To: Natural Resources Wales
From: Jen McMillan
Date: 25 February 2020
Copy: James Orme, Graham Morley
Our reference: PB5034-RHD-ZZ-XX-NT-Z-1000
Classification: Project related

Subject: Updated assessments for terrestrial ecology (excluding chough) in response to comments made on the Environmental Statement by NRW and RSPB: draft for discussion in meeting schedules 28/2/2020

Drawing title: 132kv Cable Route & Joint Pit Location
Page 4 of 7

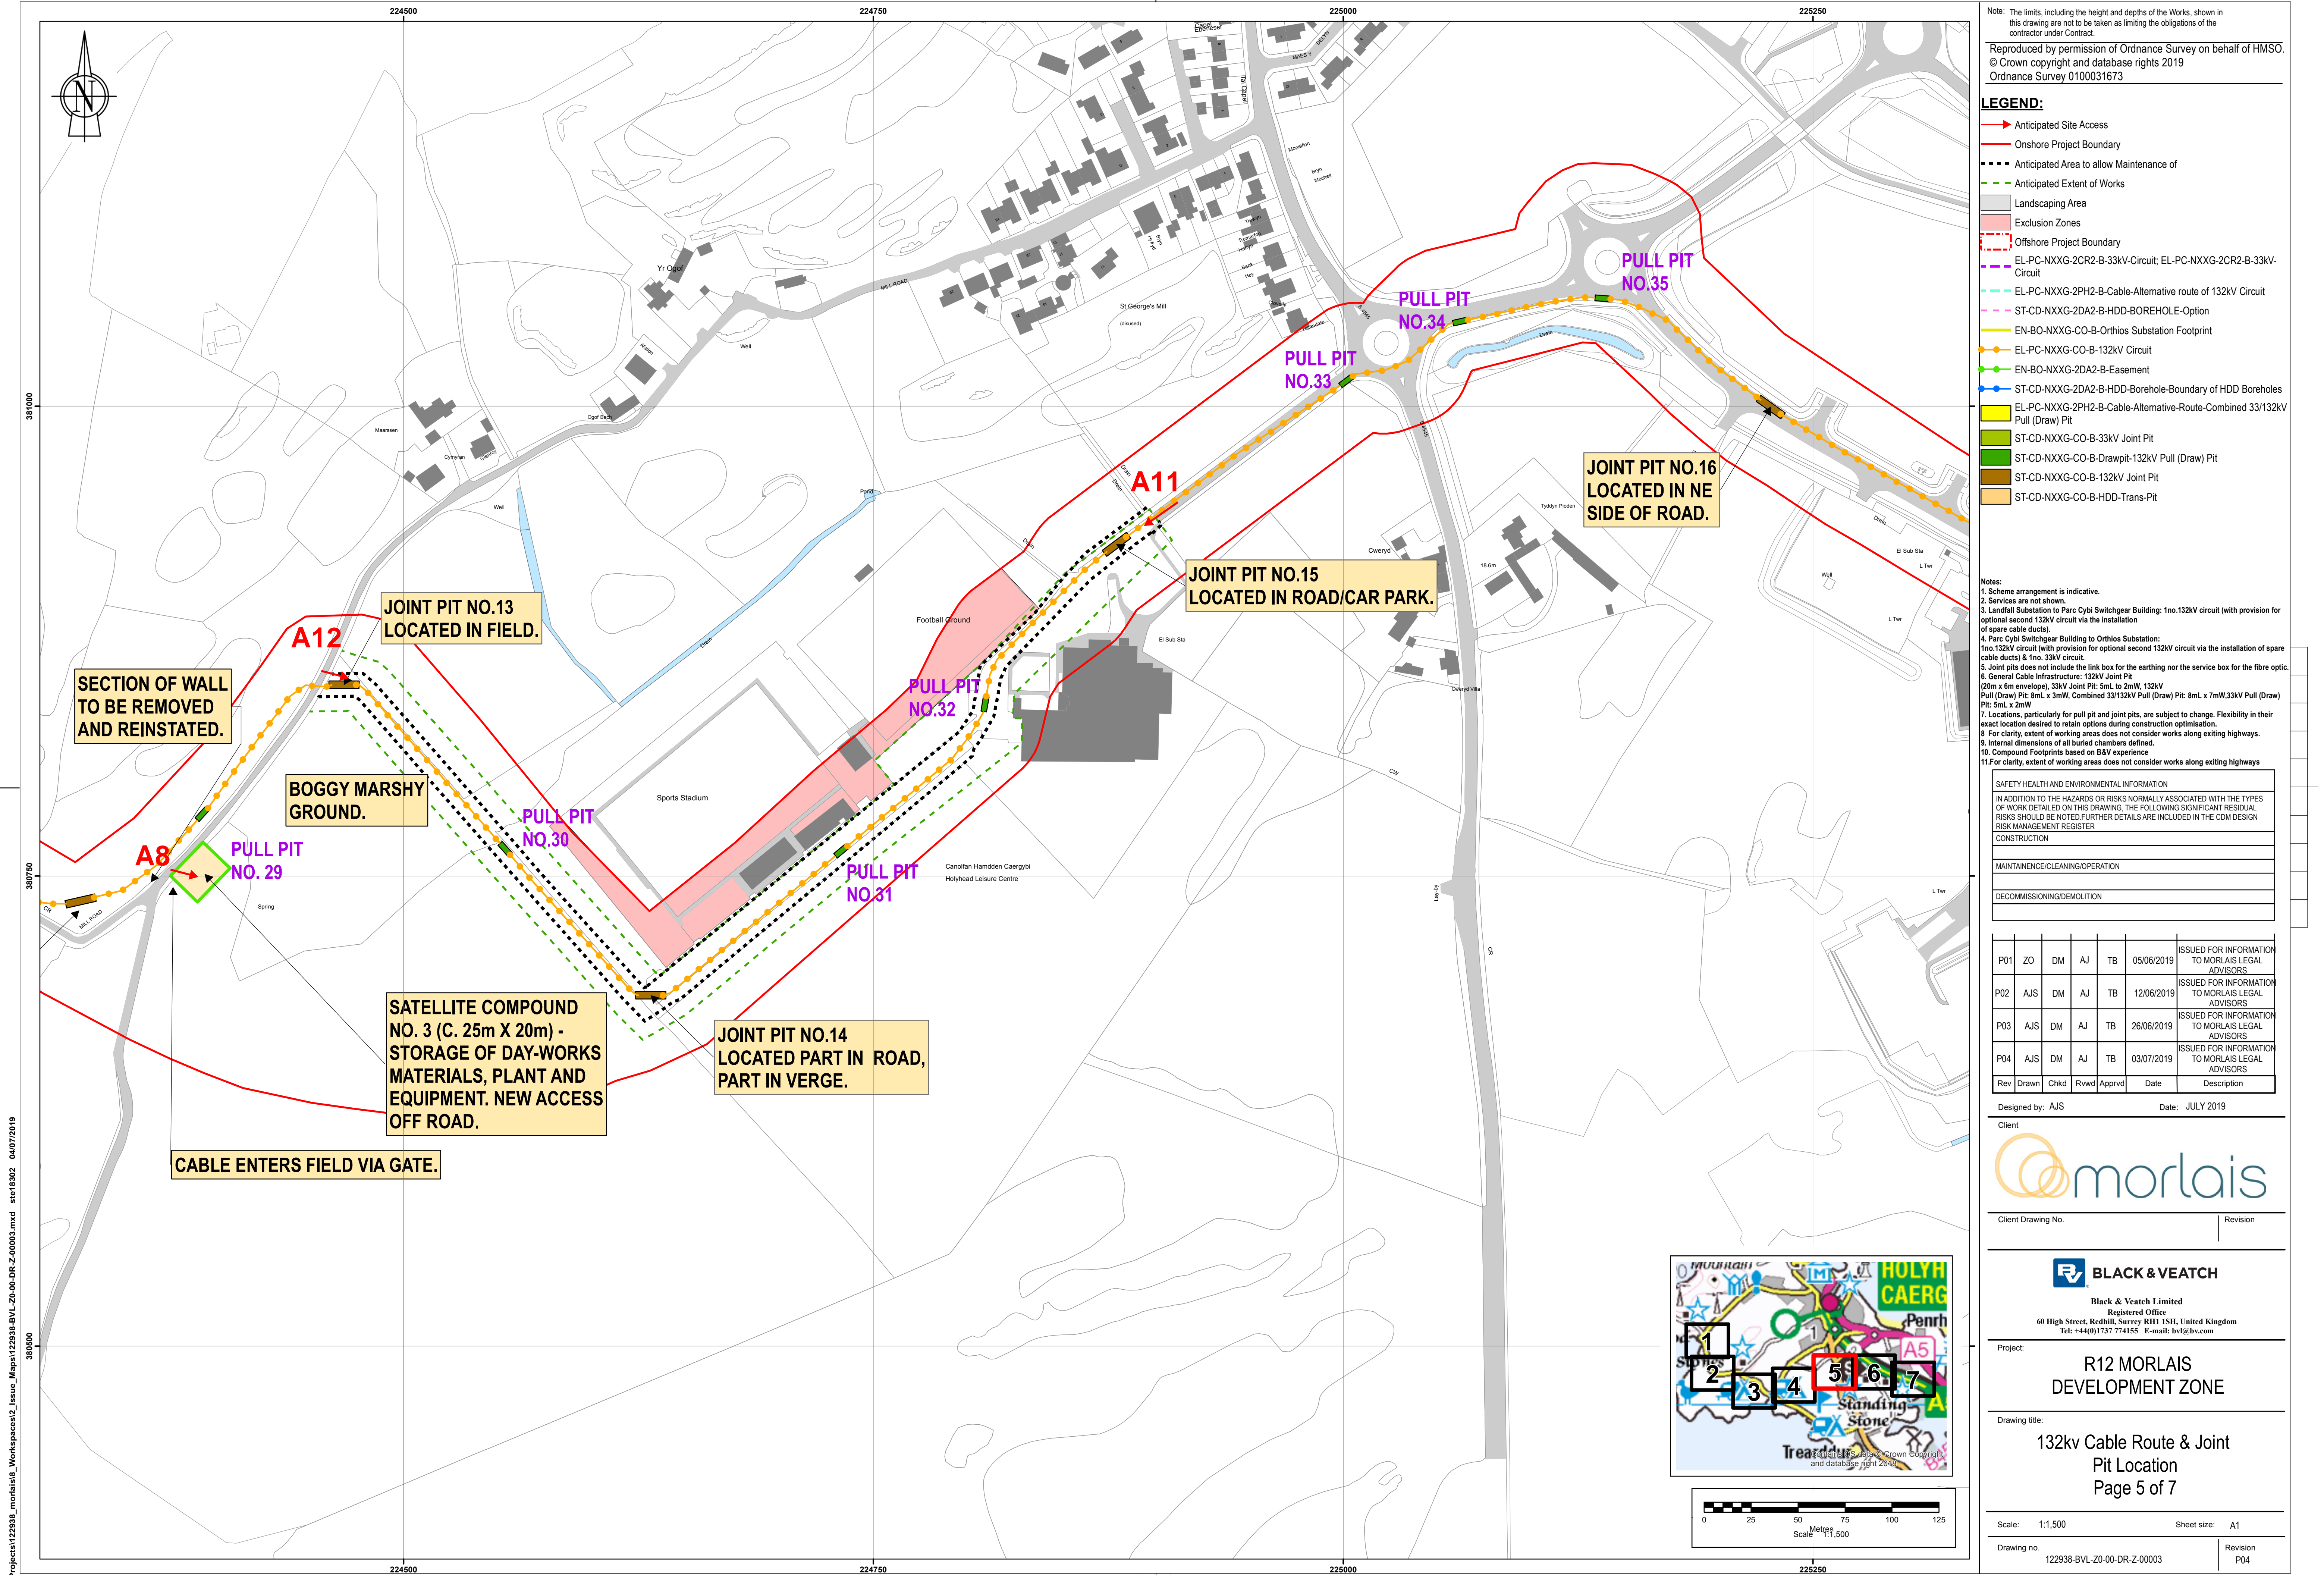
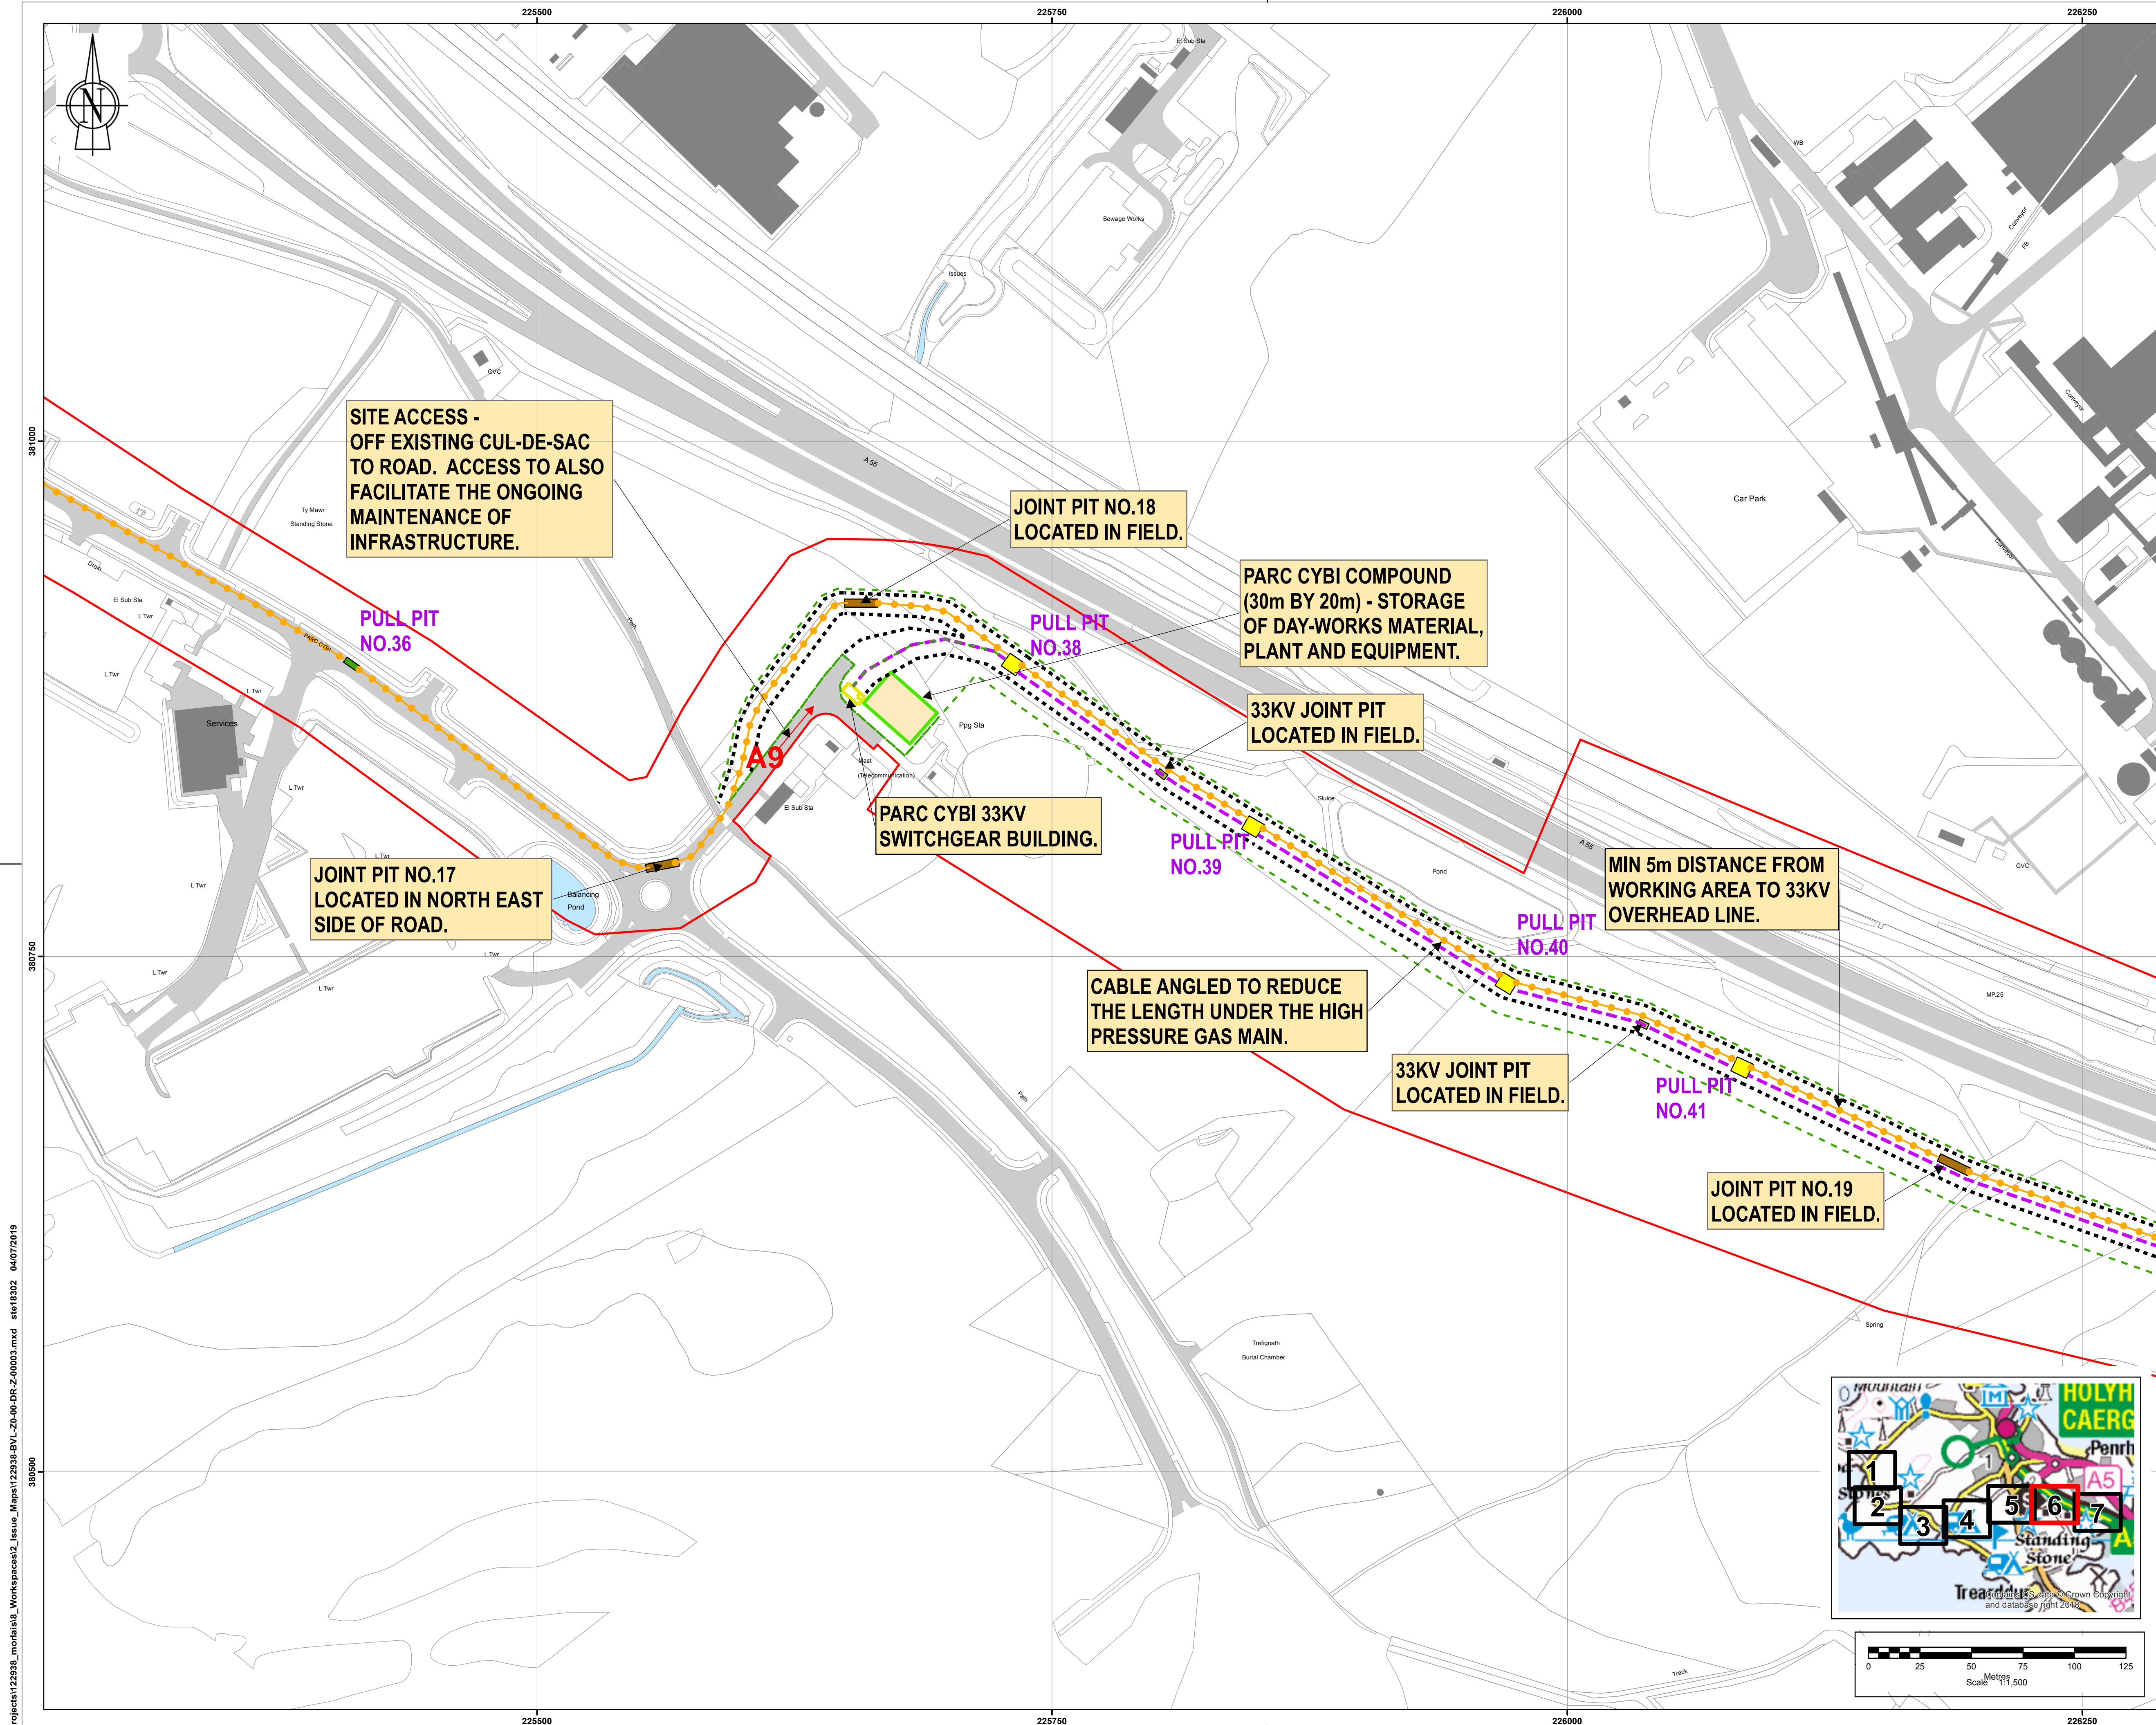
27	Paragraph 997: It should be stated here that not only will materials and equipment be stored within the construction footprint, but they will be stored outside the designated site boundary.	Methodology updated in Section 5 of this document to include for no storage in the designated site boundary
28	We advise that further work to reduce the impact on hedgerow and cloddiau due to their removal is made - possibly using HDD at these locations. NRW would expect that if the removal of any hedgerow or cloddiau cannot be avoided, a licenced ecologist or Environmental Clerk of Works (ECow) should be on site to provide the necessary expertise. The qualifications, licencing and contact details for this person should be forwarded to NRW as early as possible. NRW would expect this person to be the main point of contact for all ecological matters during this work.	Mitigation updated in Section 7.1 of this document to use trenchless crossings for cloddiau and any sensitive hedgerows

This section should be read alongside Drawing 2: 122938-BVL-Z0-00-DR-Z-00003.

Two out of the proposed nine draw-pits will be located within the unimproved neutral grassland, the other seven being located within the poor semi-improved grassland. It is proposed to leave all nine manhole covers in place, to reduce temporary disturbance to the habitat during planned or unplanned maintenance events. The footprint of the manhole covers, and the nine ground anchors will result in permanent habitat loss as presented in Table 6.2.. There will be no laydown areas for plant or equipment within the neutral grassland habitat, recognising that this habitat is considered to be of high sensitivity.

In response to consultation undertaken with NRW, who raised concerns regarding the impacts associated with the removable and re-construction of cloddiau, trenchless methods will be now employed to cross under cloddiau to avoid direct impact to these features. Consequently, there will be **negligible** impact upon the cloddiau features.
